TCR Technical Bulletin; 2nd Inlet Air Temperature Sensor for Scrutineering

TN_VAG_02/ 2021

2021 TCR TECHNICAL BULLETIN n1. 02/2021-02-24

CONNECTION WIRE ref: **TCR-AITSC-v20.1.0**

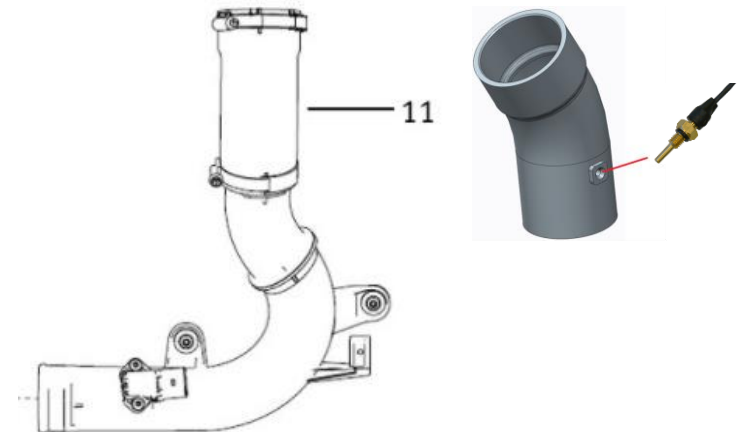
Connection wire available at the following address only;
